Garlick's Arch

Regulation 25 and Clarifications Report

Guildford Borough Council

REVIEW OF LVIA ADDENDUM
SUBMITTED AS PART OF SUPPLEMENTARY ENVIRONMENTAL STATEMENT

February 2021

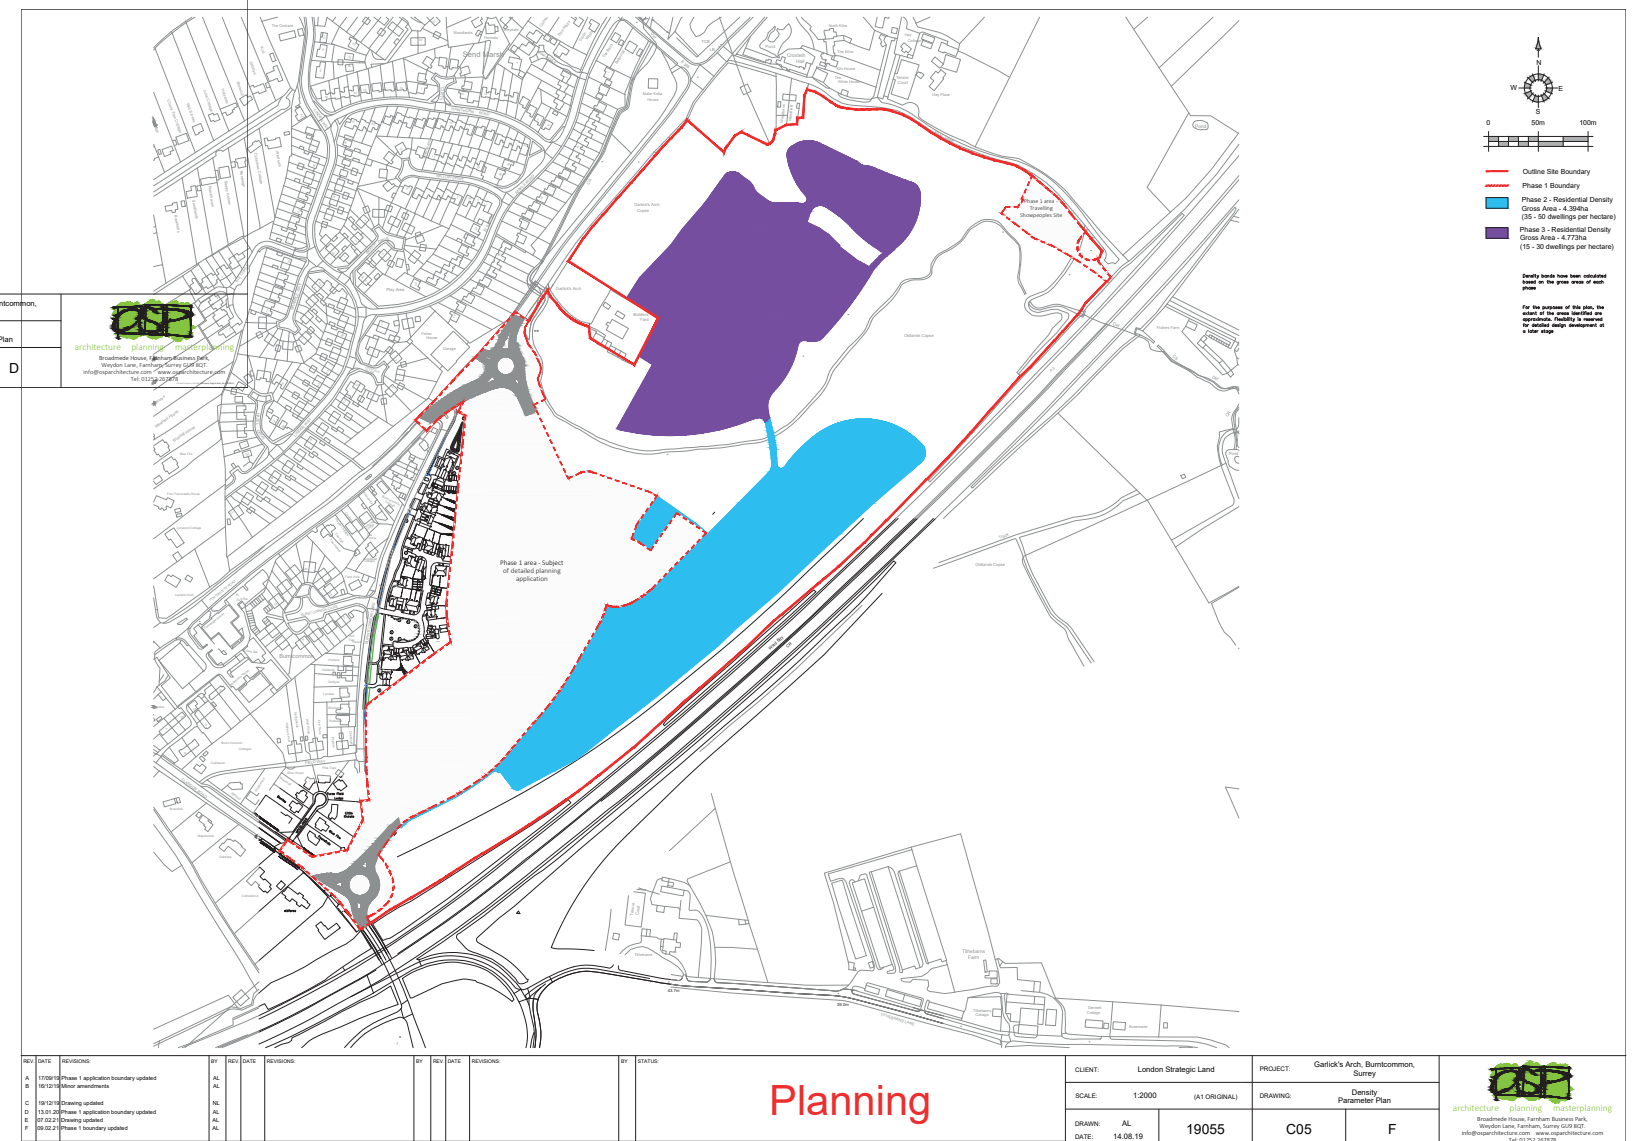
- 3.3.1. Land Use Parameter Plan**
- Phase one is subject to detailed planning application and is not shown on the 2021 Land Use Parameter Plan.
 - The dimensions of the traveling showpeoples' site have changed. Area appears to have increased in size.

- Open space layout on site has been altered.
- 3.3.2. Access and Movement Parameter Plan**
- Primary vehicular access has changed location, possibly as a result of phase two not being shown on the plan.

- 3.3.3. Landscape Parameter Plan**
- Swales and SuDS basins are not shown on the 2021 parameter plan.
 - Modifications to play strategy are observed.
 - Open space layout alterations are observed.

- 3.3.4. Building Heights Parameter Plan**
- Area in centre of site is changed from maximum two storeys to maximum 2.5 storeys.
 - Phase one is subject to detailed planning application and is not shown on the 2021 plan.

- The area of three storey maximum height structures on the southern boundary, with frontage on the A3, has increased in size.

- Phase one is subject to detailed planning application and is not shown on the 2021 plan.
